PORTLAND PUBLIC ART COMMITTEE

Wednesday, July 19, 2017

Congress Square: Sze Studio submitted development of the Shattered Sphere scheme for review, discussion. Cameron described the submittal. LaCasse described the process moving forward. Five members of the public were present.

**Congress Square Art Commission
Portland, ME**

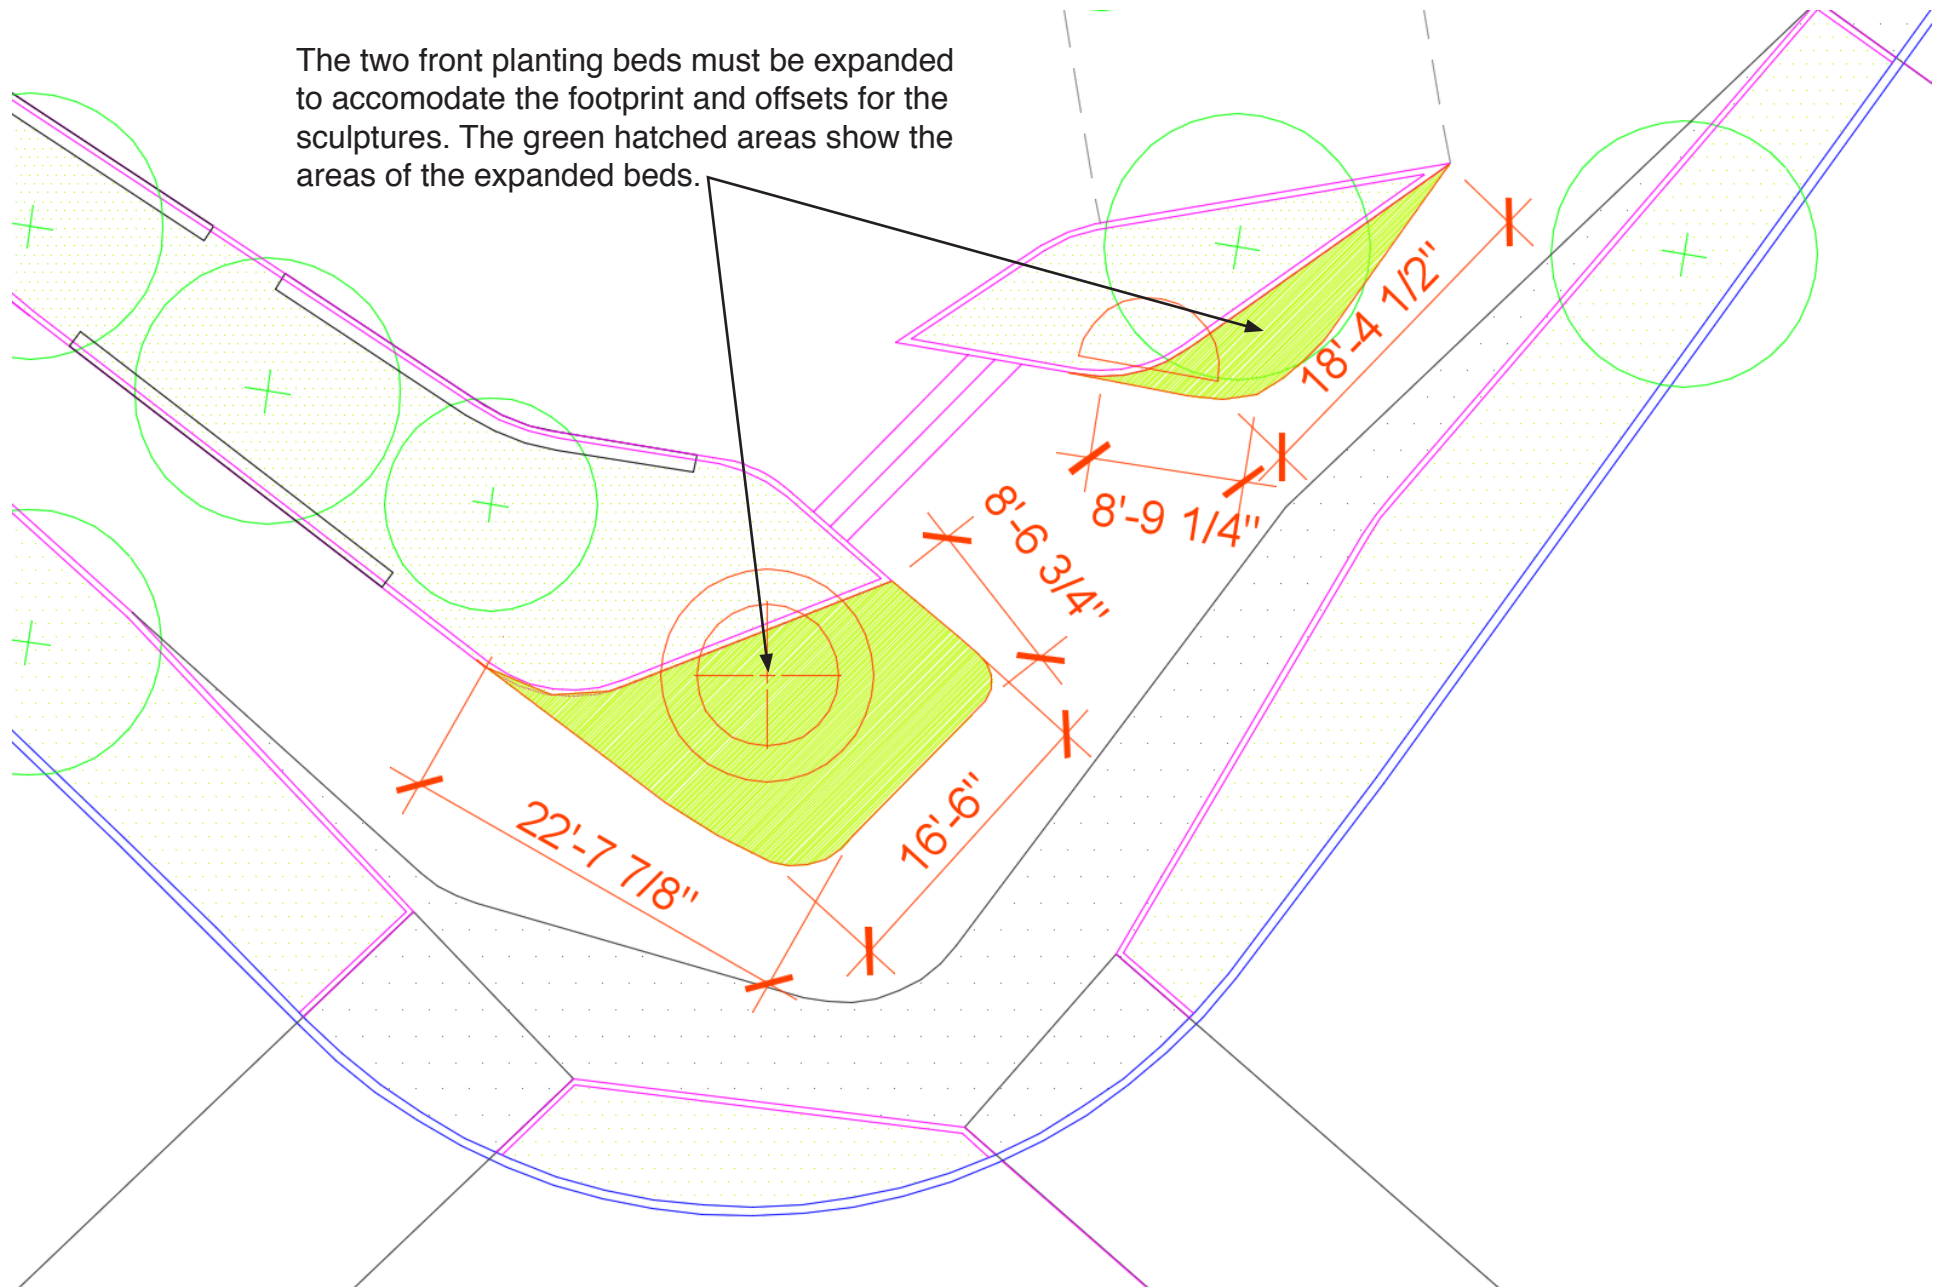
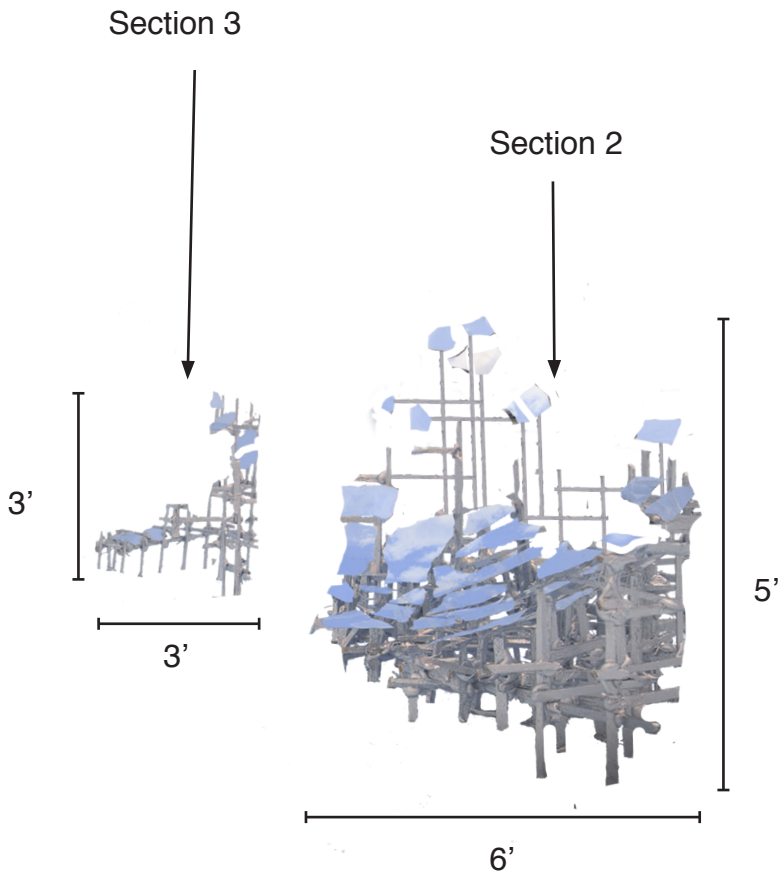
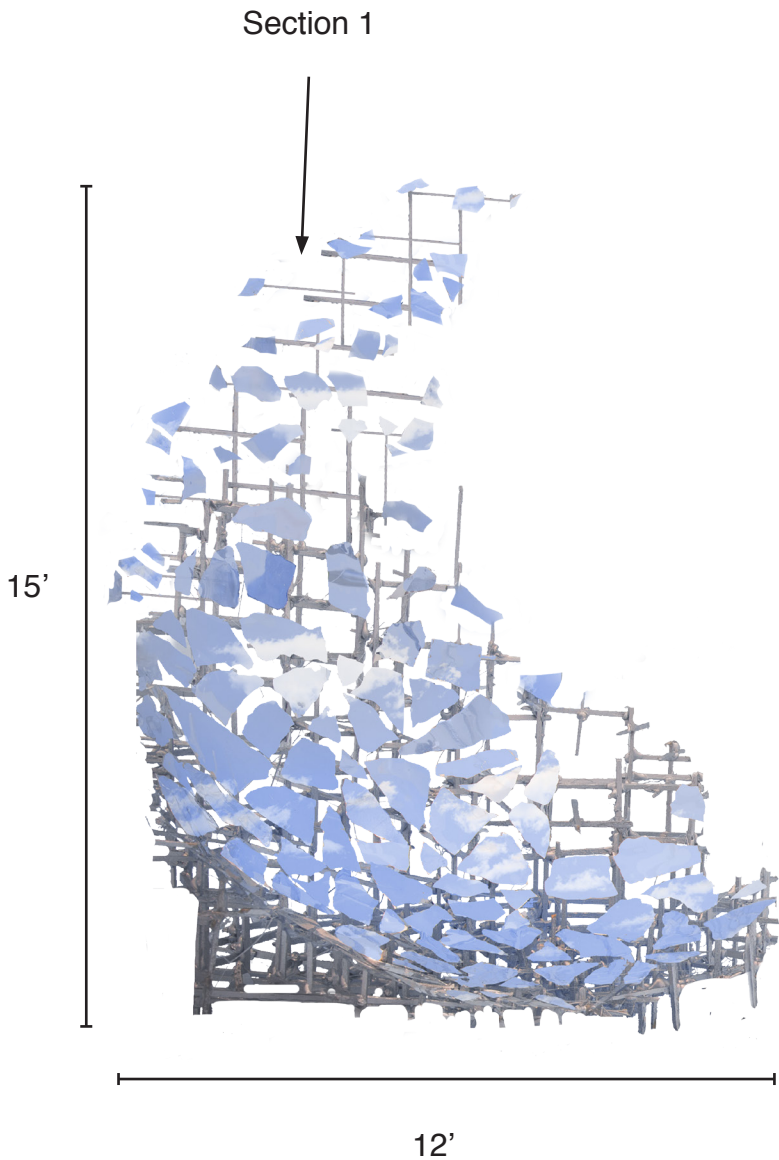
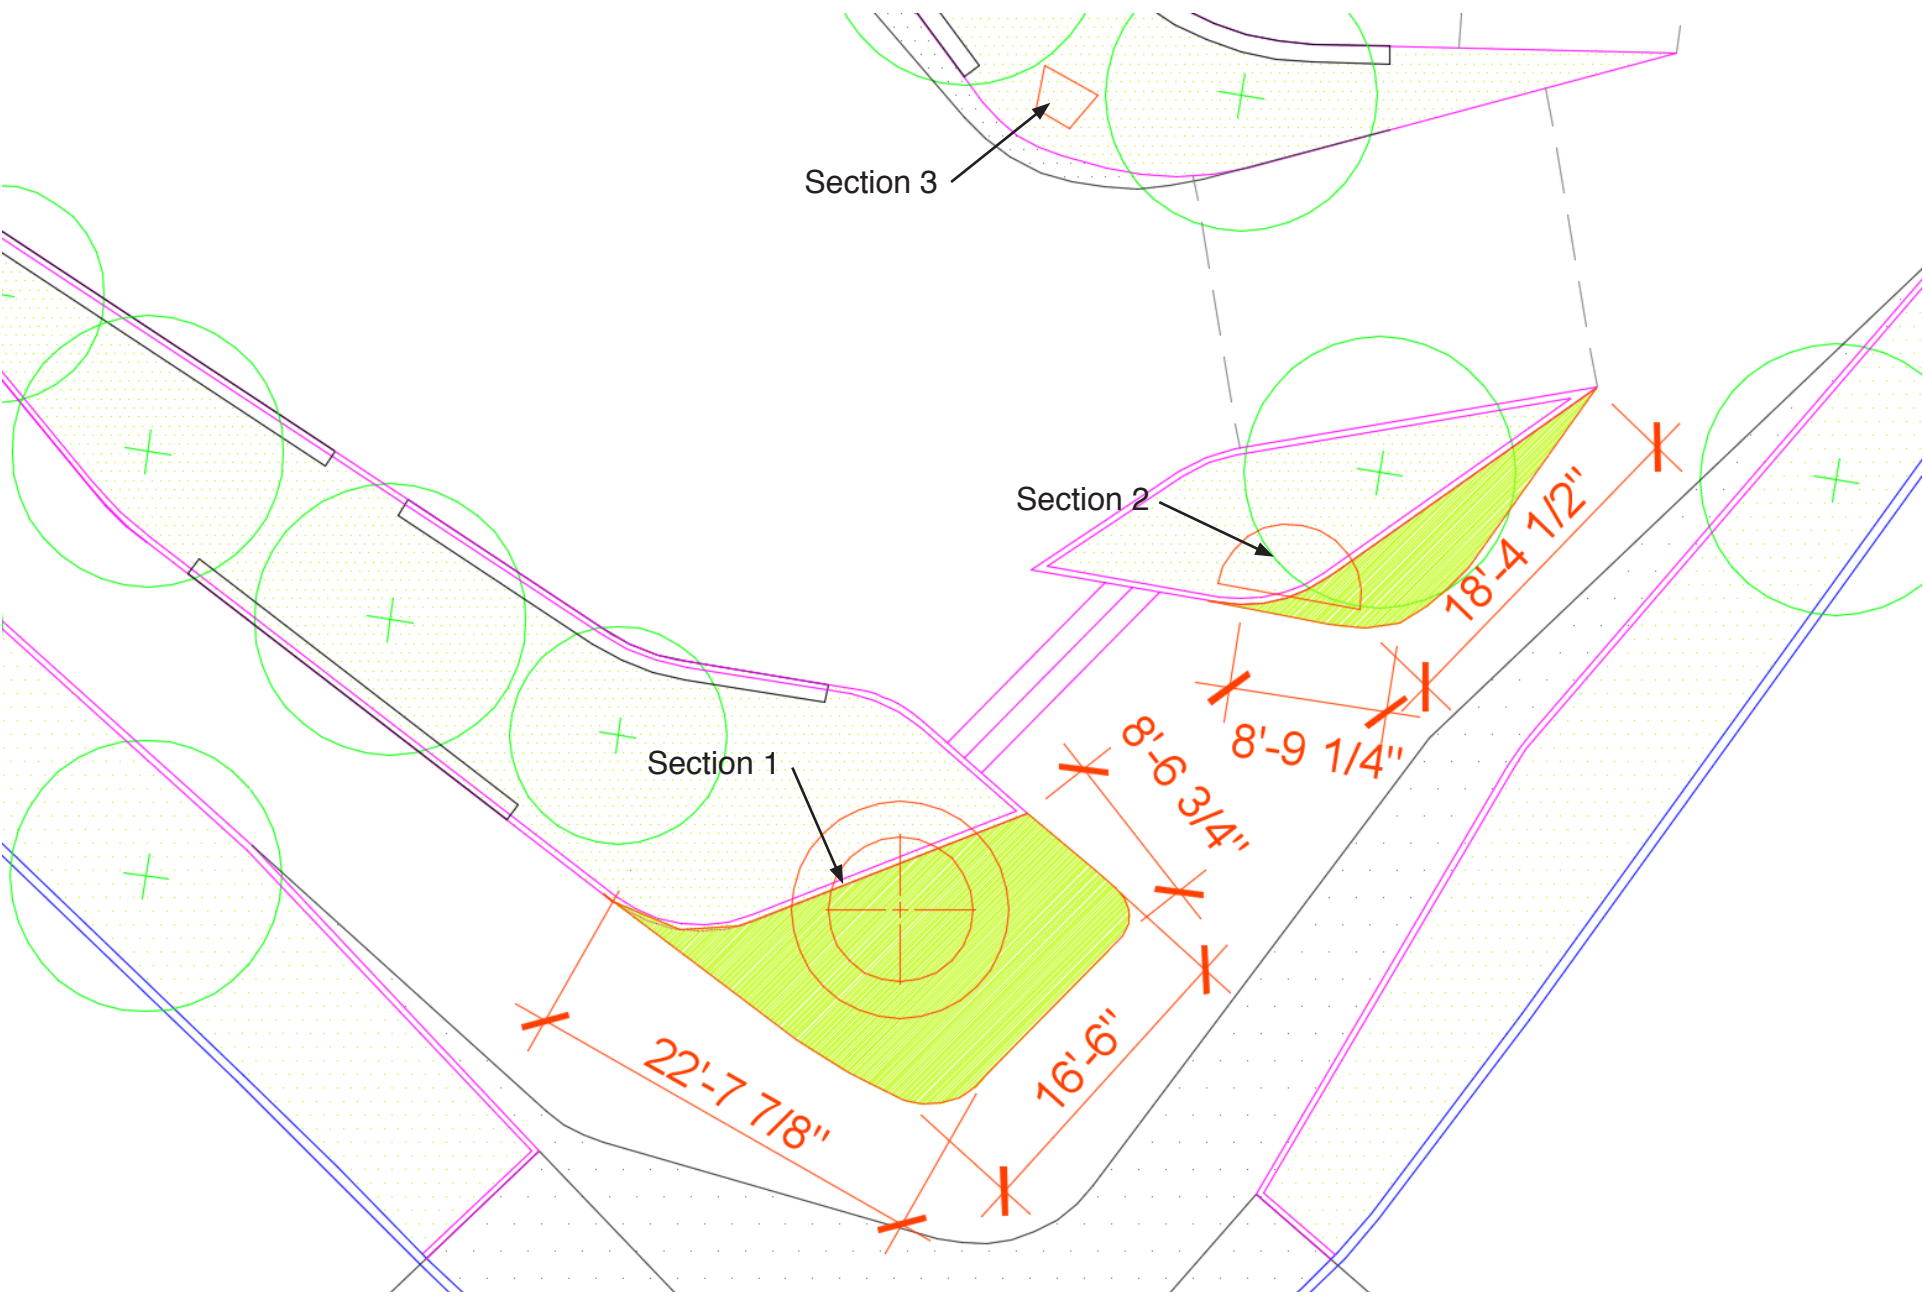
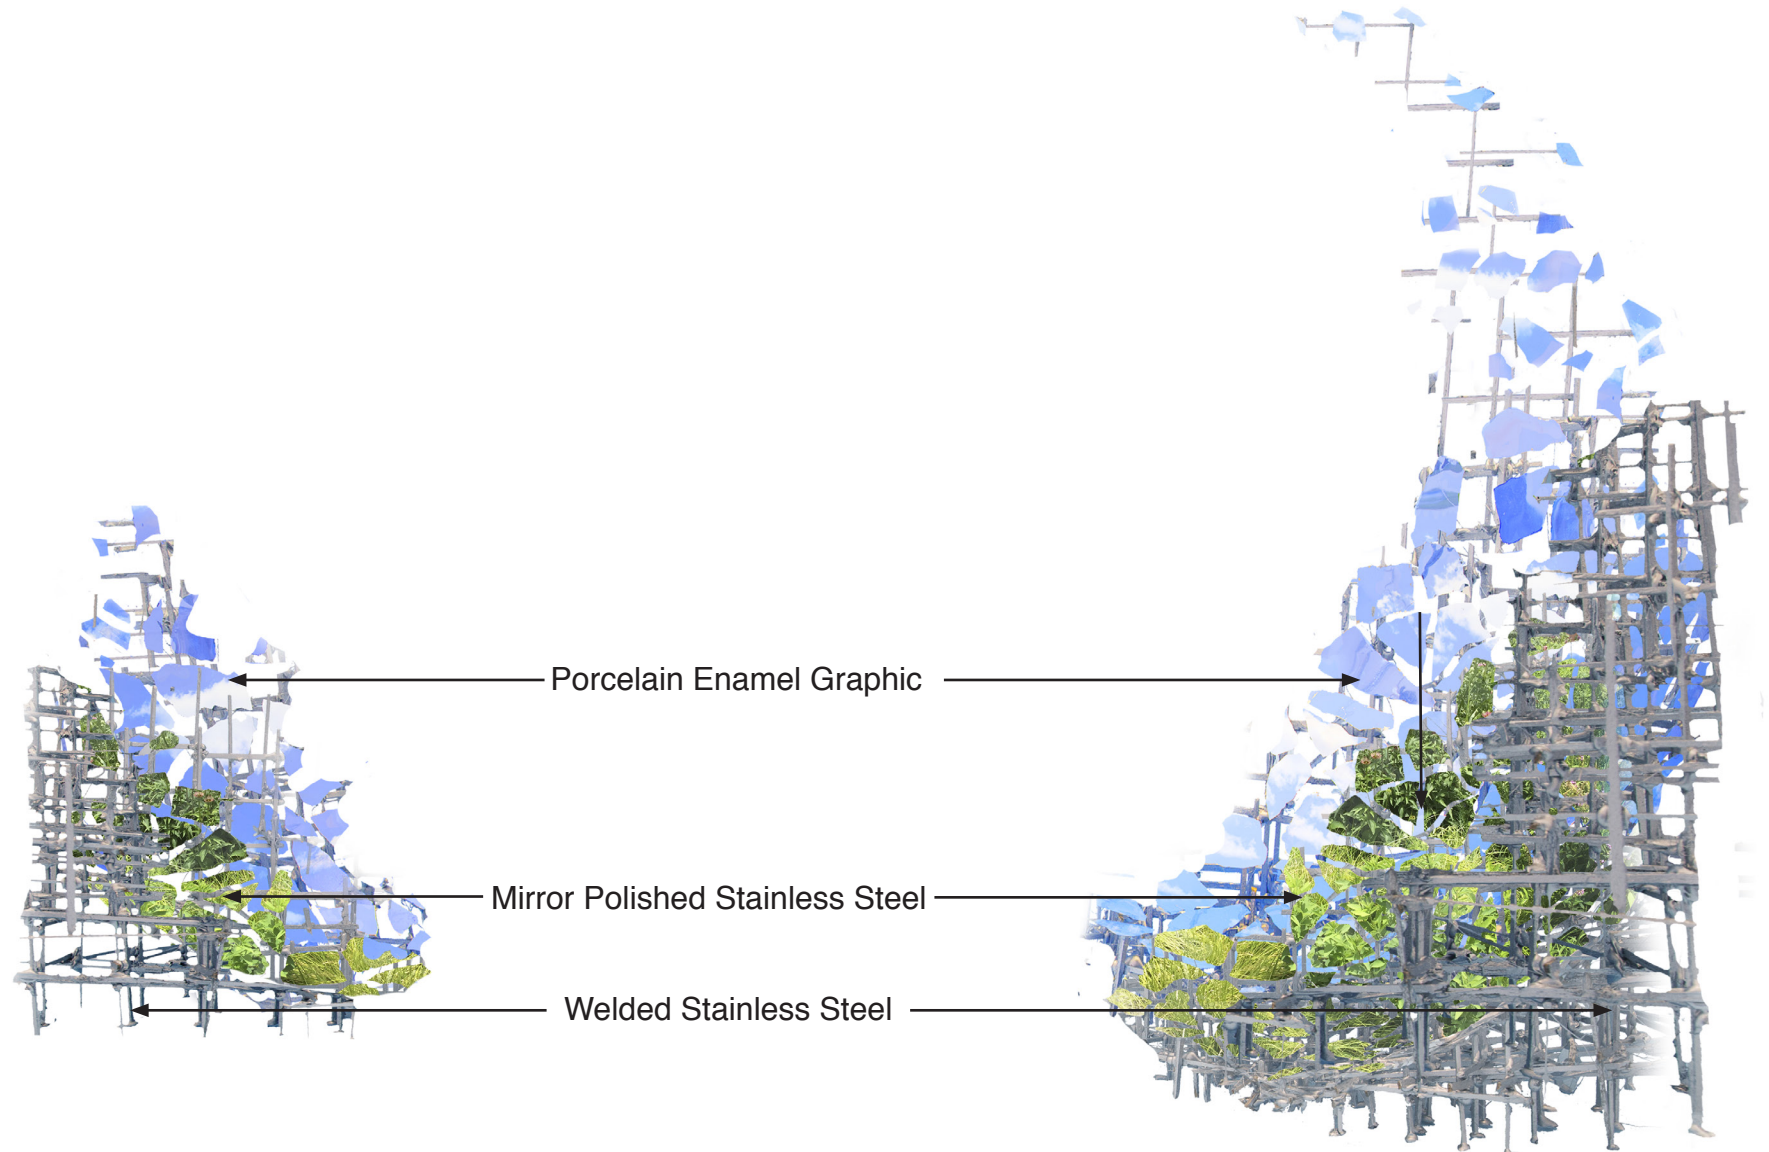
- Hildreth: Like the design, sphere should be more elevated; scaffolding may have some safety issues; handsome piece – reflectivity, gateway; move back so not viewing from the steps; more arresting and visible; like that it's embedded in the landscape.

- LaCasse: Like the idea of bringing the sky to the ground level – engaging and interactive; like that you can see through it and part of the park; has concerns about heaviness of scaffolding look and climbing safety; it is visible from the street/gateway; close to the steps may be a hindrance; like that it is three pieces trailing; How will landscape maintenance work; scale maybe should be larger; want to see all the way around in 3d model to better understand what it will be like.

- Kirby: What is the material of the scaffold? Welded steel
- Devlin: Echoes comments of others on scale – doesn't have the presence on the street as expected.

- Batson: Love piece but scaffolding seems to take away; inviting to climb on
- Crowder: High Line scaffold was much thinner – how does this one compare? How long was that installed?

- Cradock: Scaffolding is heavy; seek more visualization of orientation of sphere
- Cameron: Does the committee want a piece that invites climbing?
- Kirby: Looks broken off/jagged and therefore less inviting.

- Cradock: Is it overbuilt to accommodate climbing?
- Hildreth: We can't underestimate the amount of research Sze will do.
- Minot: Artist brings street cred to Portland; like shattered/reflective surface; too subtle/too low; don't mind the pieces being close to each other; may be comment from public on scaffolding for safety and visual impact; sea air can cause issues with stainless and affect the reflective quality; this is still early stages.

- Templeton: Would like to see more images that show the relationship to people; like the sphere being open as you enter the park
- Kirby: Agree mothership should be taller and bigger

- Joan Grant: Would the reflective surfaces cause glare issues with traffic?
- Rosanne Graef: Would like to see from other angles; scaffolding looks harsh while rest of park is flowing and organic; Like the reflectivity; uninviting with scaffolding.
- Crowder: It appears the scaffold is turned to landscape which may soften its appearance.
- Rosanne Graef: Do the reflective pieces move?
- Justin Smith: 3d model looks distorted and may not be a realistic depiction. If spacing gets large enough on the scaffolding may not be a climbing hazard. Kinetic elements may deter people from climbing on it. Has WRT given their input? Coordination needed with grading and landscape.

- Anne Pringle: How does the Shattered Sphere relate to the site? Share concerns about scaffolding being overwhelming. Would not like to see people climbing. How long will the reflectivity last? Needs to be bigger.
- Kirby: Conservator commented on polish as well – if not touched every day will hold up for quite a while.
- LaCasse: No artwork is maintenance-free.
- Chris Cantwell: Interested in the interaction between landscape and artwork; renderings don't show coordination, yet. Can't critique piece because it is not resolved. Similar to Buckminster Fuller. Raises the level of dialogue about art in this community. Make sure WRT and Sze are communicating. Does change the space.

Staff will have a follow-up call to Sze Studio with these comments especially about the reflectivity and the scaffolding.
